**PROPOSED REMONDIS INTEGRATED RECYCLING  
PARK**

**SUBMISSIONS REPORT, PREFERRED PROJECT  
REPORT AND REVISED STATEMENT OF  
COMMITMENTS**

**October 2012**

# Previously Proposed Extent of Excavation Works Construction

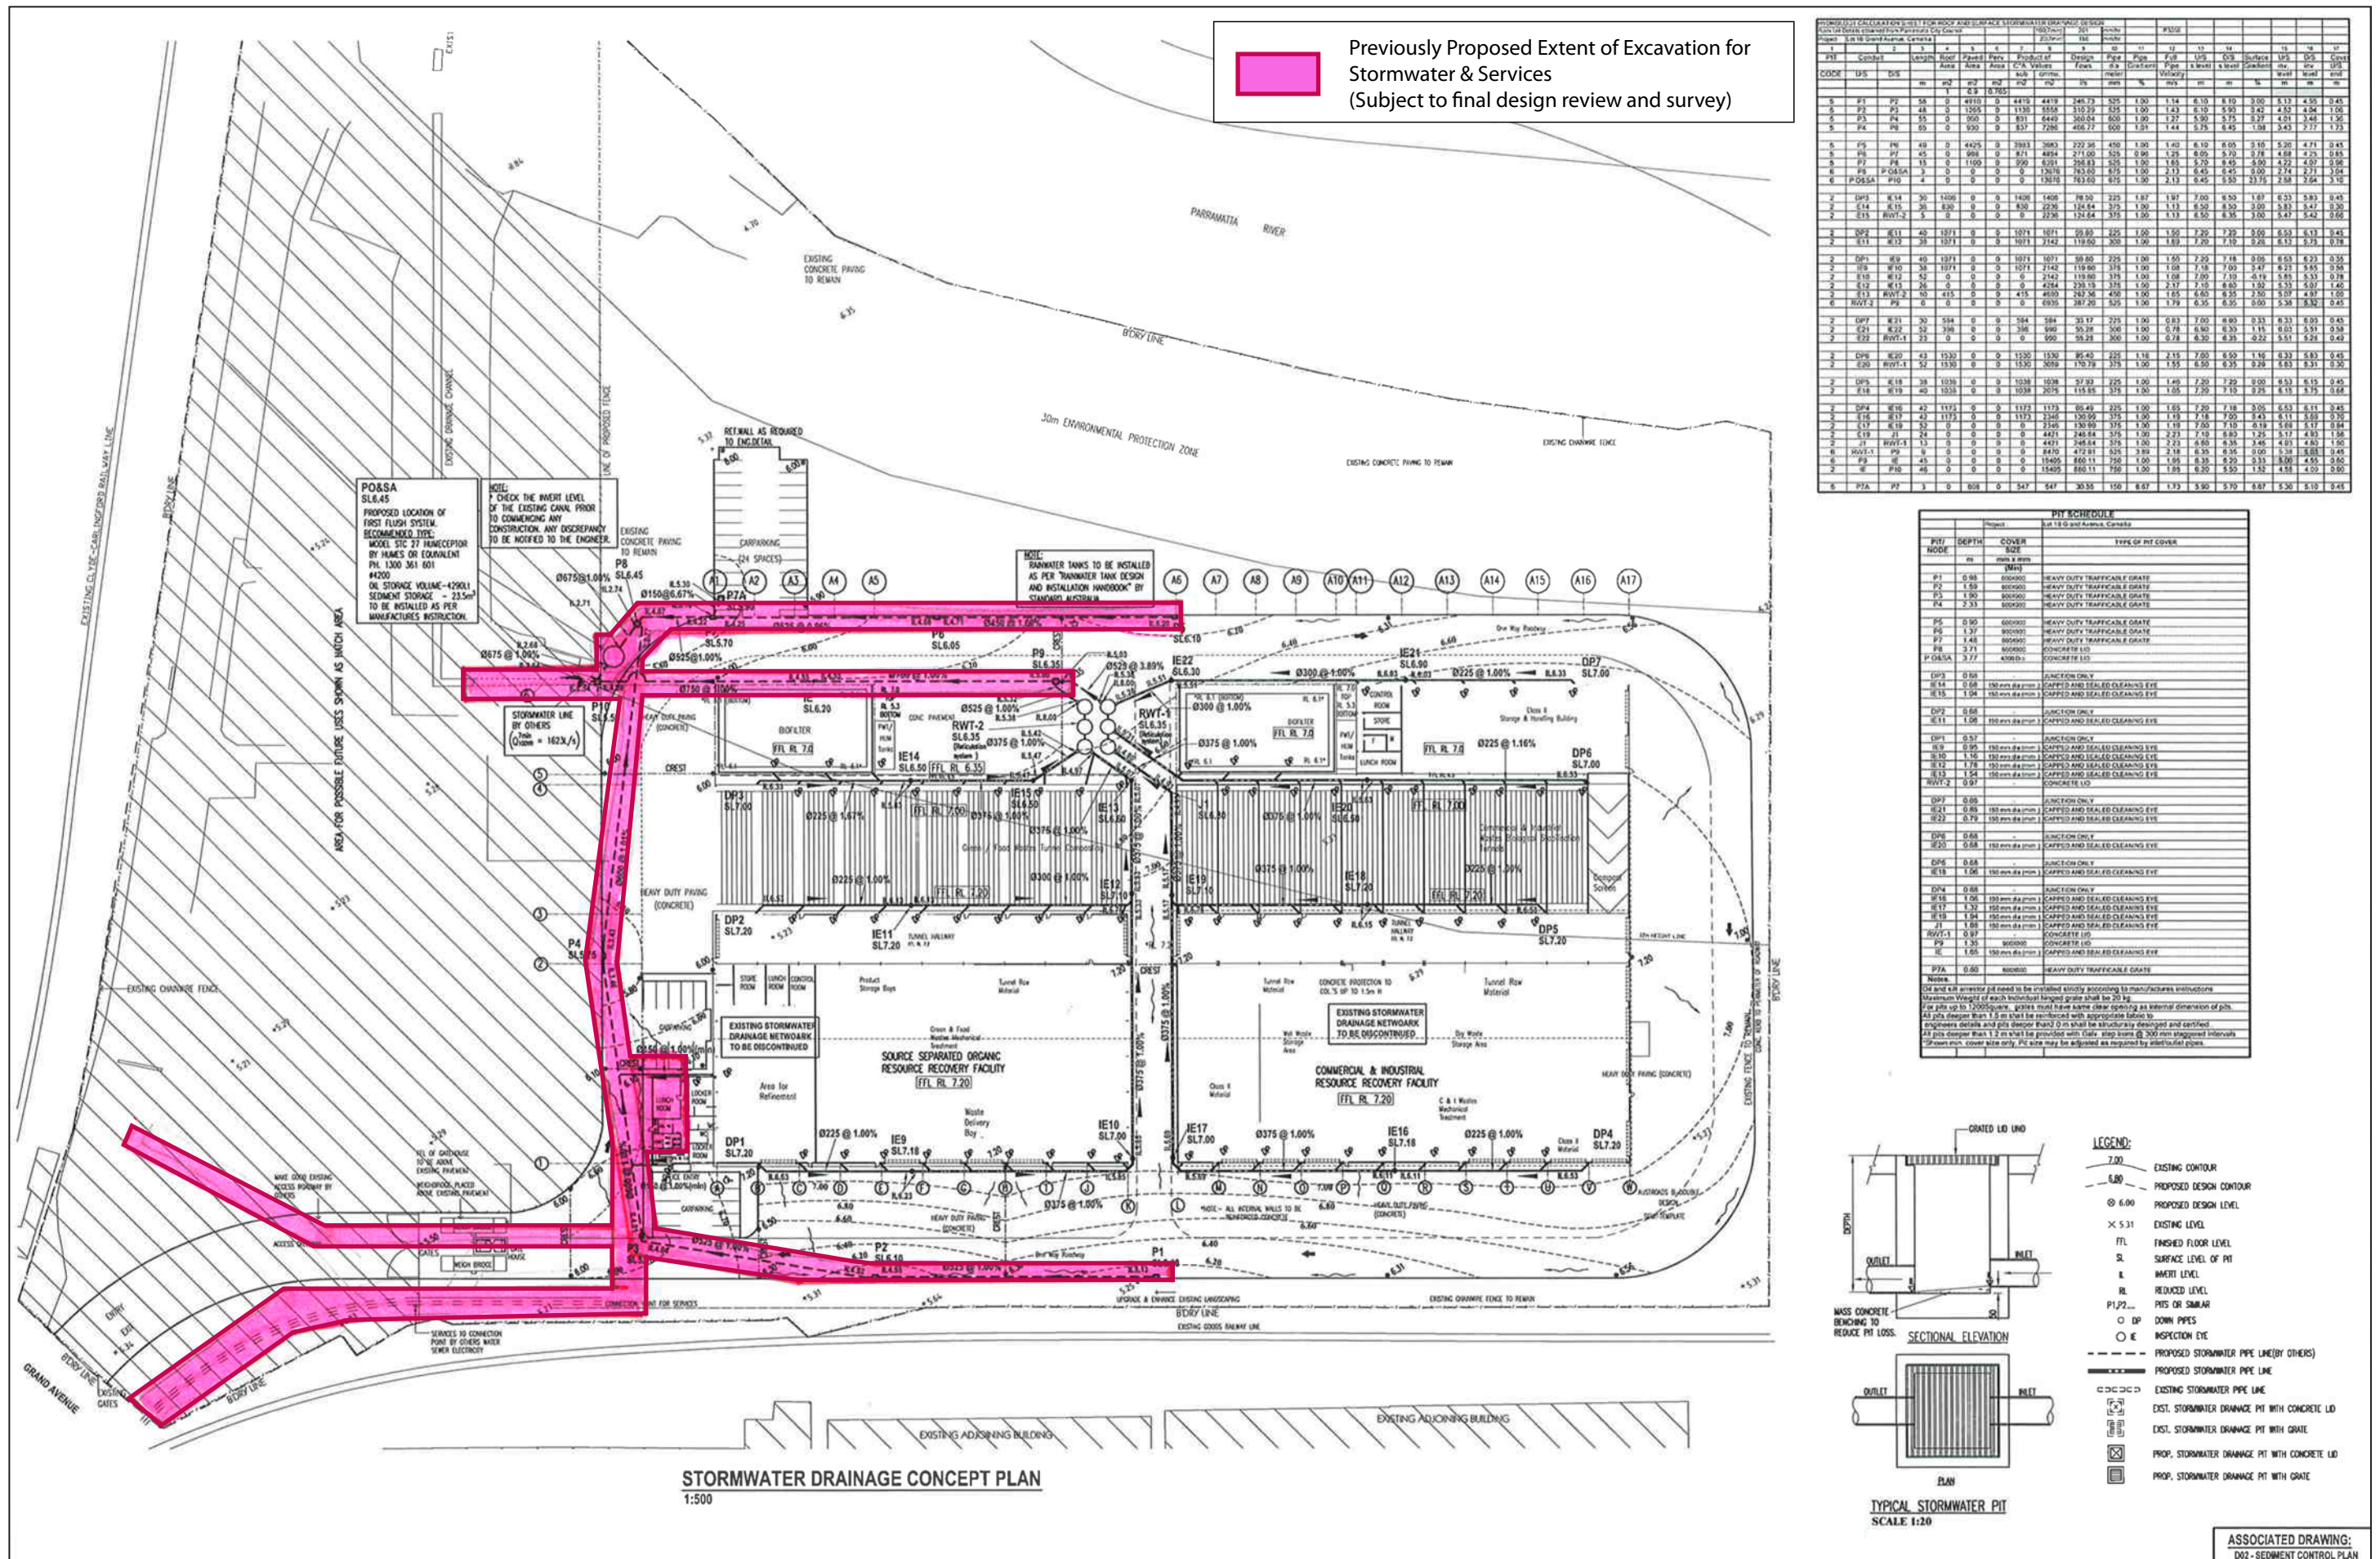
NO.	NAME	ISSUE	RESPONSE
		5. The extent of excavation works to be carried out are along the side of site that holds the most contamination and the amount of earth to be removed from this area would constitute major friable asbestos removal programme carried out by a licensed friable asbestos removal contractor and not just supervised by one.	Section 2.2 Extent of disturbance to the cap has been reduced as a result of revisions to the design for installation of services. No excavation of contaminated material will be required.

- Additional plans required to support the Site Management Plan;
- Need to consult with WorkCover NSW;
- The SMP does not allow breaching of the cap;
- The extent of excavation works would constitute a major friable asbestos removal programme which would need to be carried out by a licensed friable asbestos removal contractor and not just supervised by one;

Billbergia proposes to provide the necessary utility services to the facility comprising potable water, sewerage, electricity and telephone services and an extension of the existing stormwater system (refer Figure 4). Installation of these services will no longer require disturbance to the site cap or excavation of asbestos contaminated material.

The proposed changes with respect to the installation of services and connection to the stormwater system include no requirement to remove spoil from the site. The proposal described in the EA included generation of 1200m<sup>3</sup> of spoil as a result of excavation activities which would have required 80 vehicle loads of spoil to be removed from the site.

Figure 5 Revised Landscape Plan

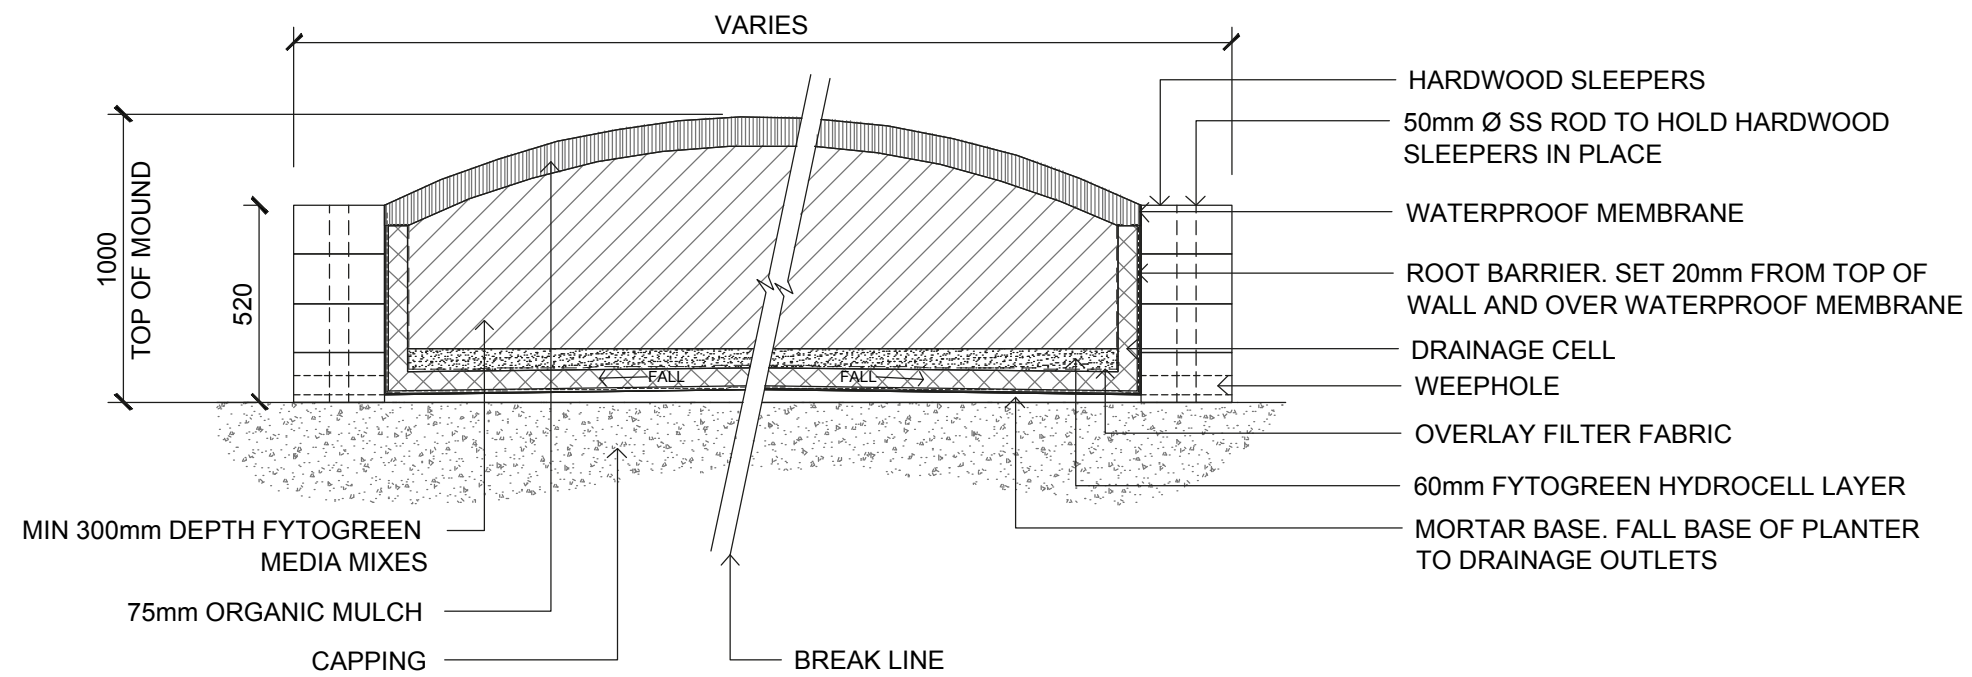
NO.	NAME	ISSUE	RESPONSE
		9. Council's longterm vision is to have public access along both sides of the river as a shared use pathway.	Sections 2.6 and 2.12 Agreed. Requirement is included in the Site Masterplan.
	Landscape and Riverbank Treatment Options	<ol style="list-style-type: none"> <li>1. Councils supports the removal of the Cabbage Gum and Jacaranda at the site entrance.</li> <li>2. Environment Protection Zone: <ul style="list-style-type: none"> <li>• Do not support use of moveable containers.</li> <li>• Propose replacing removable containers with non-movable contained raised mounded area covering the majority of the EPZ.</li> <li>• Concern regarding erosion on the northern bank of the site under the concrete slab as a result of the Parramatta River – Need to investigate and implement appropriate measures.</li> </ul> </li> </ol>	<p>Noted.</p> <p>Section 2.6 Site MasterPlan revised. SMP includes requirements for monitoring of this area.</p>

The landscape works proposed within the EPZ have been revised as outlined in Section 2.6 (refer Figures 5 and 6). Provision has been made for future public access through this area. The landscaping will provide screening of the facility and improve the amenity of the area.
